### **REMARKS**

Applicant : Kalyan Handique et al.  
Serial No. : 10/075,371  
Filed : February 15, 2002  
Page : 32 of 32

Fig. 1

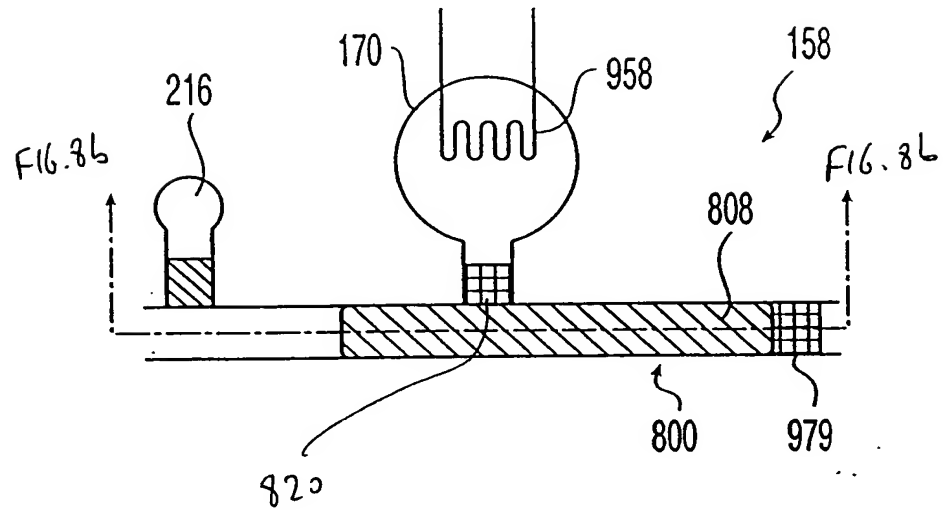
FIG. 1 is amended to delete reference numeral 134. Applicants respectfully point out that, as would be clear from the accompanying portion of the specification, the correct reference numeral 134 refers to a different element, as shown in FIG. 2.

Fig. 9a

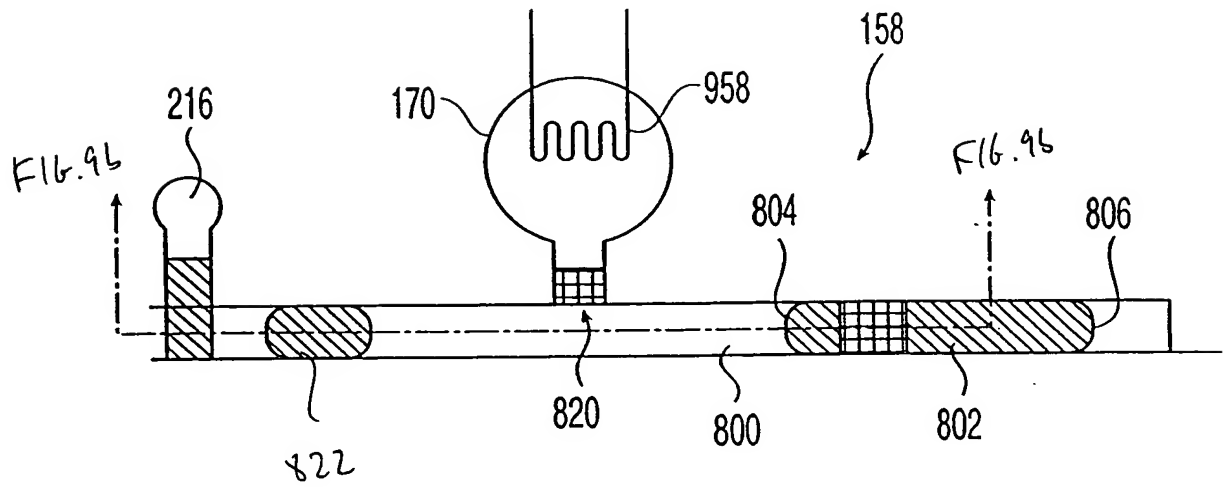
FIGs. 2, 4, 8a, and 9a are amended to insert references to corresponding figures wherein arrows are shown to indicate a cross sectional view.

FIGs. 9a and 9b have been amended to insert reference numeral 822, as found in the accompanying description in the specification as filed.

Fig. 11a

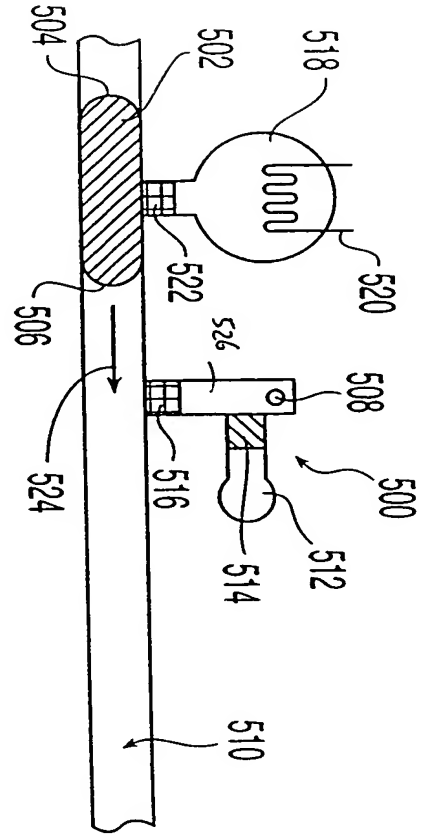
FIGs. 11a – 11c have been amended to insert reference numeral 526, and FIG. 11b has been amended to insert reference numeral 504, as found in the accompanying description in the specification as filed.

Fig. 12a

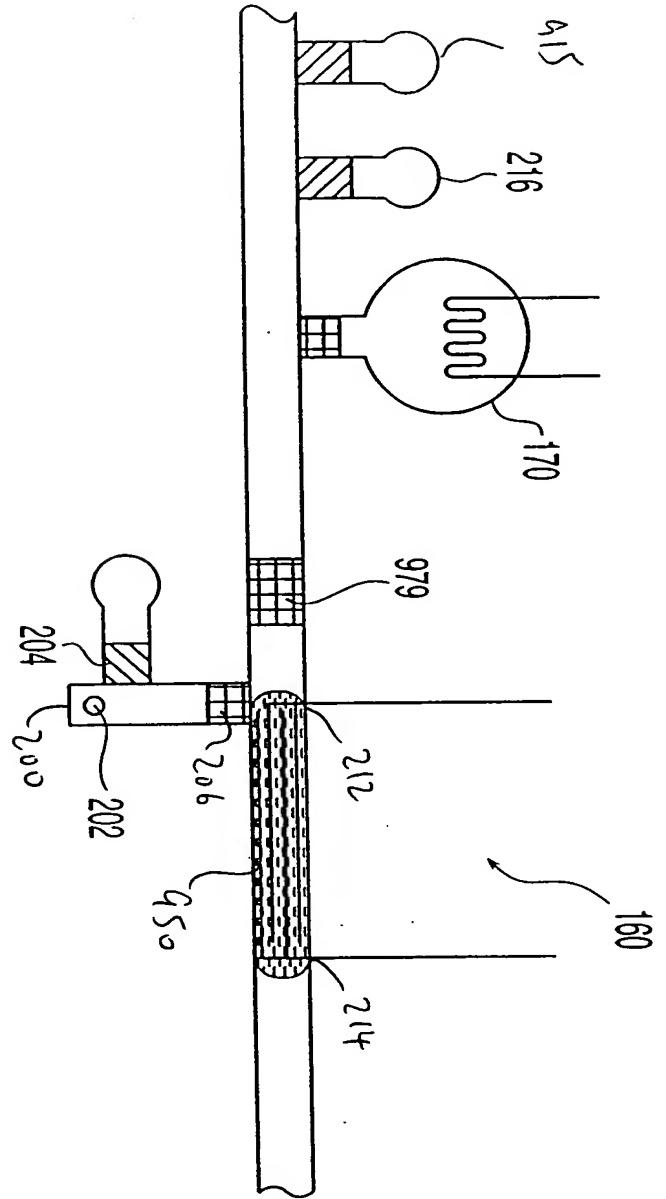
FIGs. 12a and 12b have been amended to insert various reference numerals, including 200, 206, 212, 214, 915, and 950. The positioning of such reference numerals is based on other drawings as filed and the accompanying description found in the specification as filed.

Fig. 15c

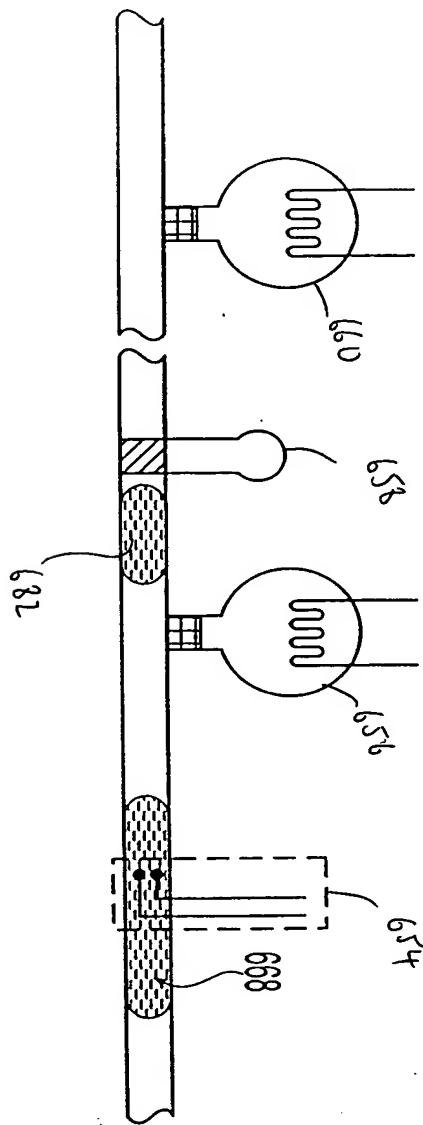
FIG. 15c has been amended to insert various reference numerals, including 654, 656, 658, 660, and 682. The positioning of such reference numerals is based on other drawings as filed (in particular FIGs. 15a and 15b) and the accompanying description found in the specification as filed.
